UNITED STATES
DEPARTMENT OF THE INTERIOR
BUREAU OF LAND MANAGEMENTRECEIVED
OCD ArtesiaFORM APPROVED
OMB NO. 1004-0137
Expires: January 31, 2018SUNDRY NOTICES AND REPORTS ON WELLS
Do not use this form for proposals to drill or to re-enter an
abandoned well. Use form 3160-3 (APD) for such proposals.NOV 18 2019
DISTRICT/ARTESIA/OCD

1. Type of Well <input type="checkbox"/> Oil Well <input checked="" type="checkbox"/> Gas Well <input type="checkbox"/> Other		5. Lease Serial No. NMLC065421
2. Name of Operator CIMAREX ENERGY COMPANY OF CO		6. If Indian, Allottee or Tribe Name
3a. Address 600 N MARIENFELD STE 600 MIDLAND, TX 79701		7. If Unit or CA/Agreement, Name and/or No. NMNM111029
3b. Phone No. (include area code) Ph: 432-687-3033		8. Well Name and No. BRADLEY 14 FEDERAL COM 1
4. Location of Well (Footage, Sec., T., R., M., or Survey Description) Sec 14 T24S R26E SWNW 1650FNL 990FWL		9. API Well No. 30-015-32672-00-C1
		10. Field and Pool or Exploratory Area BLACK RIVER
		11. County or Parish, State EDDY COUNTY, NM

** BLM REVISED ** BLM REVISED ** BLM REVISED ** BLM REVISED ** BLM REVISED **

Bradley 14 Federal Com #1

Bradley 14 Federal Com #1

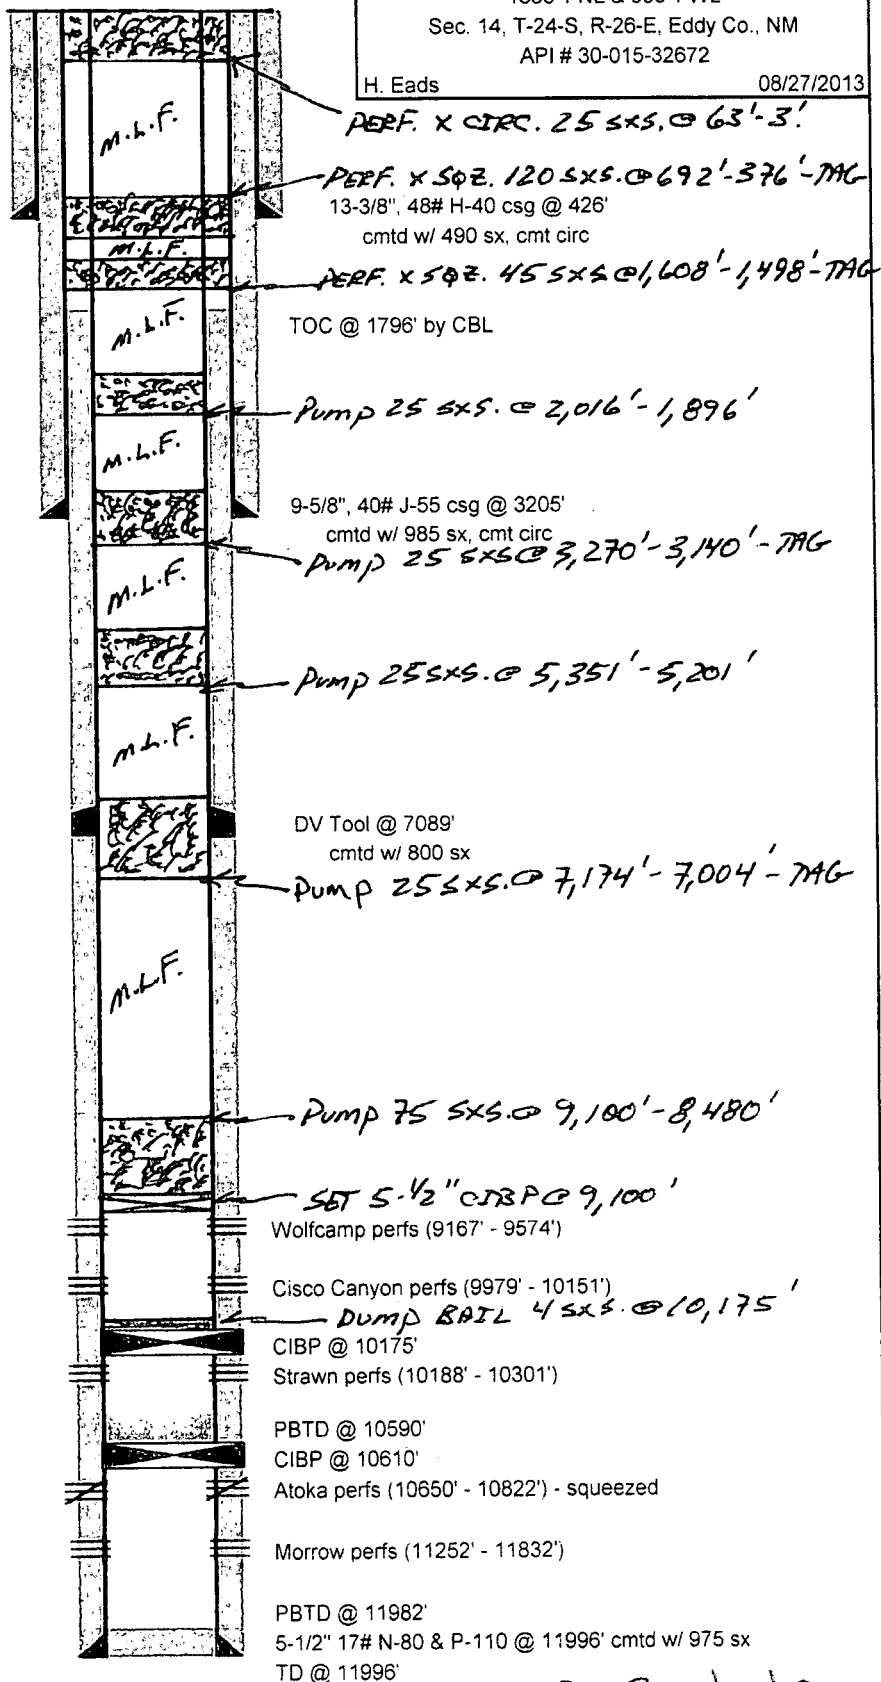
- *Set 5 1/2" CIBP @ 9929. Dump Bail 35' cmt @ 9929
- 1) DUMP BAIL 4 SXS.CMT. @ 10,175'-10,143'.
 - 2) SET 5-1/2" CIBP @ 9,100'; PUMP 75 SXS.CMT. @ 9,100'-8,480'(T/WCMP.); CIRC.WELL

- 3) PUMP 25 SXS.CMT. @ 7,174'-7,004'(5-1/2" DV TOOL); WOC X TAG CMT. PLUG.
 - 4) PUMP 25 SXS.CMT. @ 5,354'-5,204'(T/BNSG.). 5513-5353
 - 5) PUMP 25 SXS.CMT. @ 3,270'-3,140'(9-5/8" CSG.SHOE); WOC X TAG CMT. PLUG.

- 6) PUMP 25 SXS.CMT. @ 2,016'-1,896'(T/DLWR.).
 - 7) PERF. X ATTEMPT TO SQZ. 45 SXS.CMT. @ 1,608'-1,498'(B/SALT); WOC X TAG.
 - 8) PERF. X ATTEMPT TO SQZ. 120 SXS.CMT. @ 692'-376'(T/SALT, 13-3/8" CSG.SHOE); TAG.

- 9) PERF. X CIRC. TO SURF., FILLING ALL ANNULI, 25 SXS.CMT. @ 63'-3'.
 - 10) DIG OUT X CUT OFF WELLHEAD 3' B.G.L.; VERIFY CMT. TO SURF. ON ALL ANNULI; WELD ON STEEL PLATE TO CSGS. X INSTALL DRY HOLE MARKER.
